Edits to P802.3bs D1.2 for Alignment Marker Mapping and Insertion

119.2.4.4 Alignment marker mapping and insertion

<Replaces current Figure 119-4>

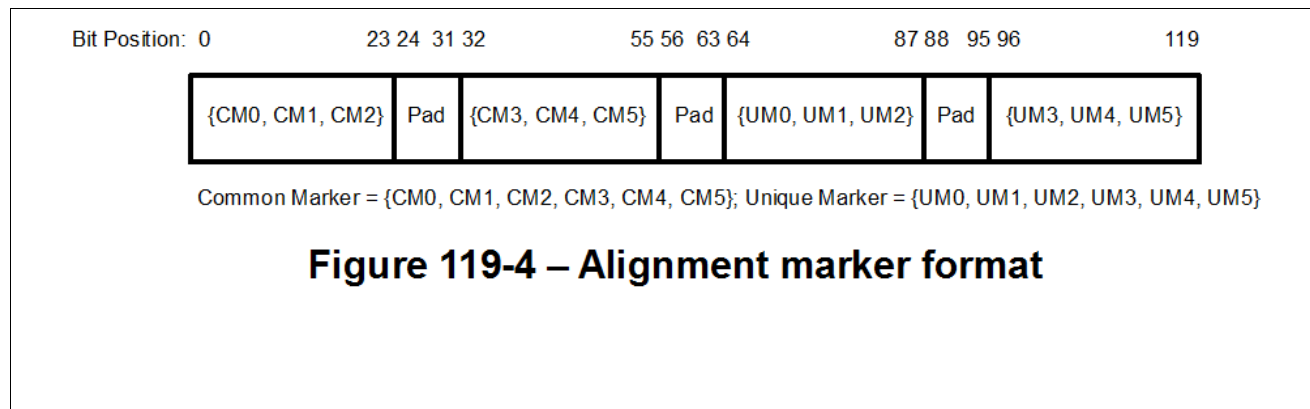
The format of the each PCS lane's alignment markers is shown in Figure 119-4. There is a portion that is common across all alignment markers (designated as CM₀ to CM₇₅), and then a unique portion per PCS lane (designated as UM₀ to UM₆₅). Common synchronization logic independent of the received PCS lane number can be used with the common portion art of the alignment marker.

a) am_x<23:0> is set to CM₀, CM₁, and CM₂, as shown in Figure 119-4 (bits 23:0) using the values in Table 119-1 for PCS lane number x.

As shown in Figure 119-4 (bits 31:24) is an 8-bit pad value of PRBS9 pattern bits, where bit 6*x is the first PRBS9 bit output of the 8-bit pad.

As shown in Figure 119-4 (bits 63:56) is an 8-bit pad value of PRBS9 pattern bits, where bit 4*x+128 is the first PRBS9 bit output of the 8-bit pad.

As shown in Figure 119-4 (bits 95:88) is an 8-bit pad value of PRBS9 pattern bits, where bit 2*x+256 is the first PRBS9 bit output of the 8-bit pad.

Figure 119-5—Alignment marker Mapping to PCS lanes

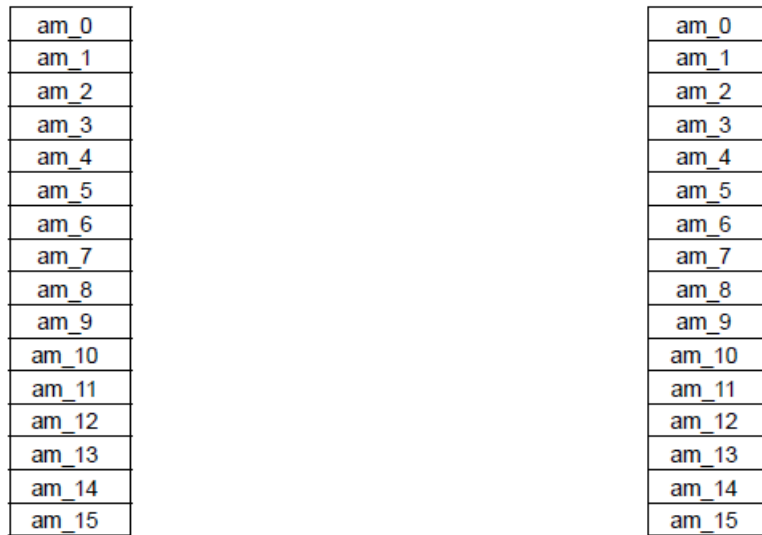
The variable am_mapped is then derived from 10-bit interleaving the group of 16 alignment markers am_x per the following procedure.

am_mapped<160*k+20*j+9:160*k+20*j> = am_{2*j}<10*k+9:10*k>

am_mapped<160*k+20*j+19:160*k+20*j+10> = am_{2*j+1}<10*k+9:10*k>

am_mapped<160*k+20*j+9:160*k+20*j> = am_{2*j+1}<10*k+9:10*k>

am_mapped<160*k+20*j+19:160*k+20*j+10> = am_{2*j}<10*k+9:10*k>
